Hampstead Heath Ponds (Ladies, Men's & Mixed) –
2022/2452/P - Map

2022/2452/P – Hampstead Ponds – Photos

Delegated Report (Members Briefing)		Analysis sheet		Expiry Date:		02/08/2022	
		N/A		Consultation Expiry Date:		07/08/2022	
Officer				Application Number(s)			
Adam Greenhalgh				2022/2452/P			
Application Address				Drawing Numbers			
Hampstead Heath Men's, Mixed and Ladies Ponds Hampstead Heath N6 6JH				Please refer to draft decision notice			
PO 3/4		Area Team Signature		C&UD		Authorised Officer Signature	
Proposal(s)							
Improvement and refurbishment works at Hampstead Heath Swimming Ponds (Mixed, Mens and Ladies) including replacement railings, adapted changing facilities and a new steward's hut (Ladies Pond), a new disabled persons changing facilities and hoists (Men's and Mixed Ponds).							
Recommendation(s):		Grant Conditional Planning Permission					
Application Type:		Full Planning Application					
Conditions or Reasons for Refusal:		Refer to Draft Decision Notice					
Informatives:

Proposed 2m high metal railings and gate – Ladies Pond

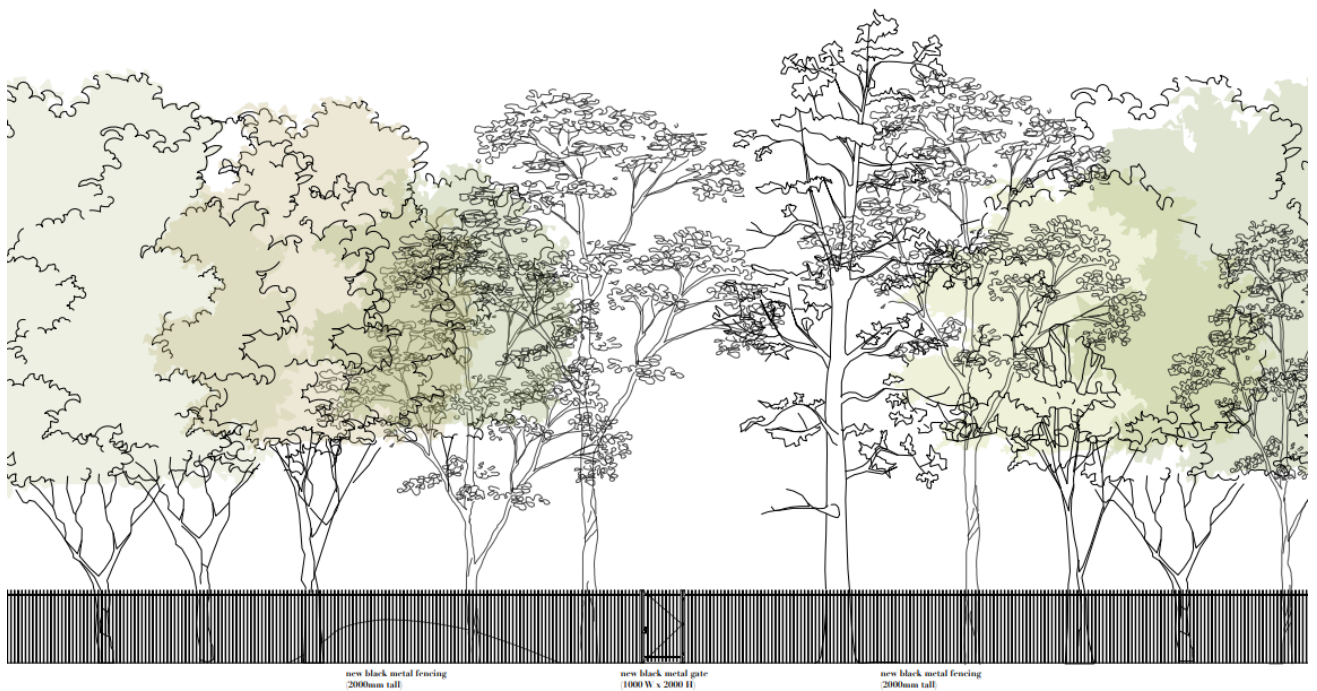
- *Inappropriate appearance and exclusive appearance of raised railings and gates*

- *The raised railings and gates would not result in any fundamental change to the openness and character of the Ladies Pond or heath. Any perception of 'loss of openness' or exclusion would be more than off-set by the benefit of increased security for people and property at the Ladies Pond (See 'Design and effects on open space and character below)*

Proposed steward's hut – Ladies Pond

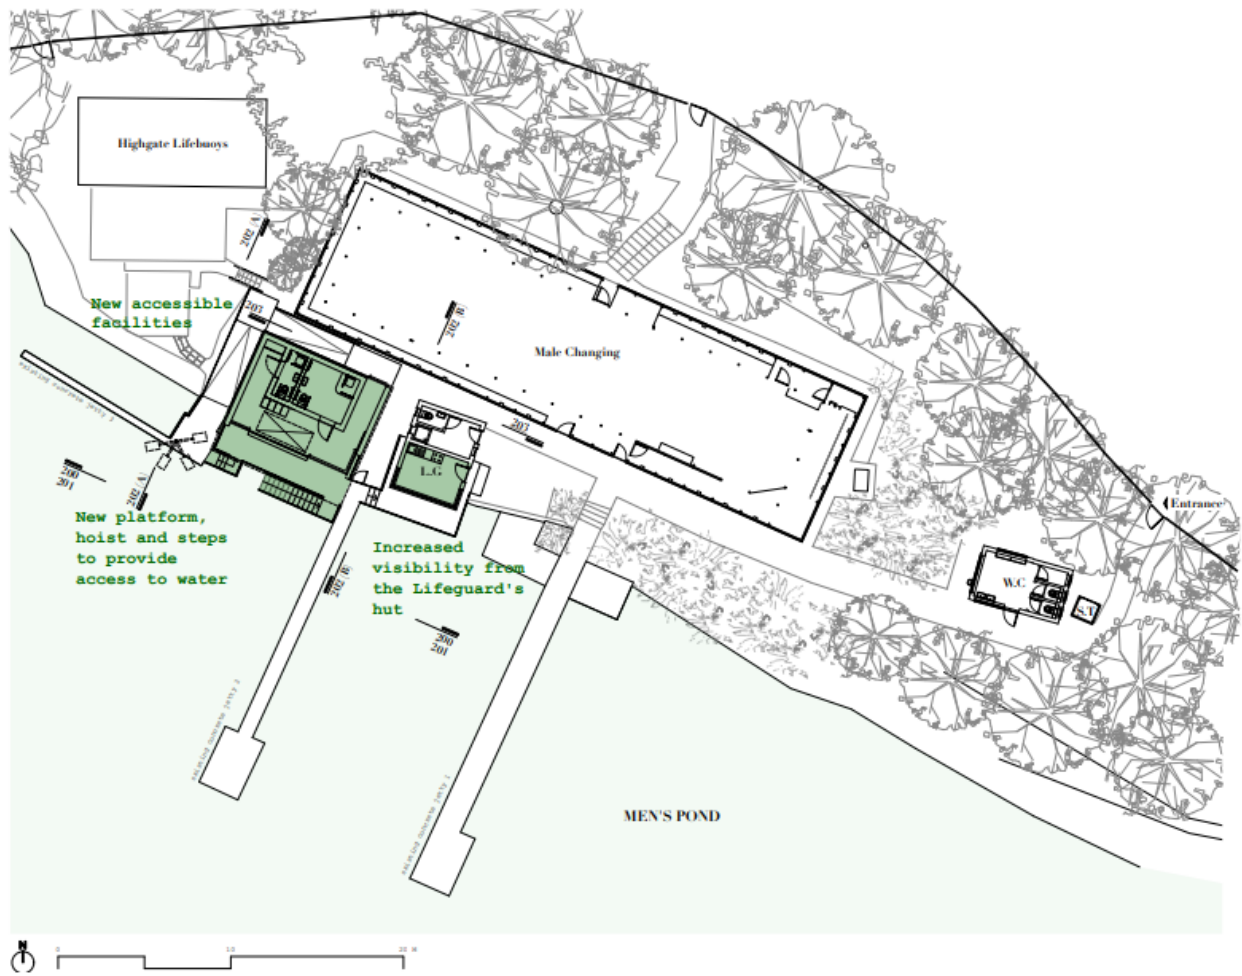
- *Reduced access / loss of safety due to siting of steward's hut (obstruction)*

- *Steward's hut fails to include equal access provision (for staff/occupants/users); separation of staff*

The proposed steward's hut would not obstruct the comings and goings of users on the path.

The proposed steward's hut would be sited to the side of the path to and from the Ladies Pond. It would not, in itself, prejudice the safe use of the path and it would be no more likely to result in queues across the path than the existing temporary cabin.

It is considered that any adaptations which might be necessary to comply with DDA legislation could easily be undertaken without raising any significant planning issues. The staffing arrangements (i.e. stewards separate from lifeguards) are not planning matters.

New disabled persons pavilion, steps into water, ramped access to a disabled person's hoist and enlarged window in lifeguard hut at Men's Pond

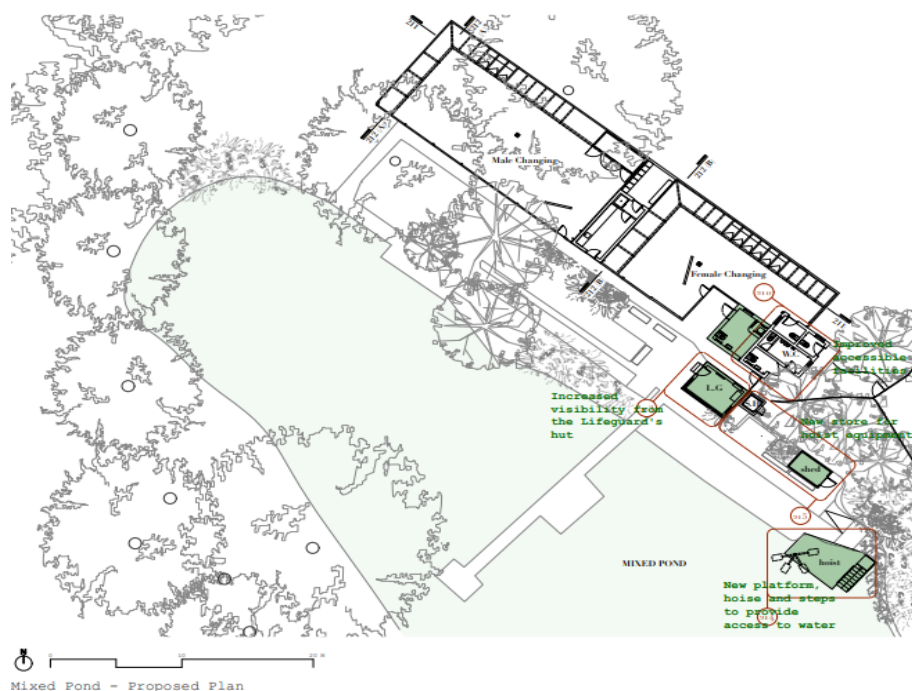
- *Loss of openness as a result of new changing facility:*

See 'Design and effects on open space and character' below
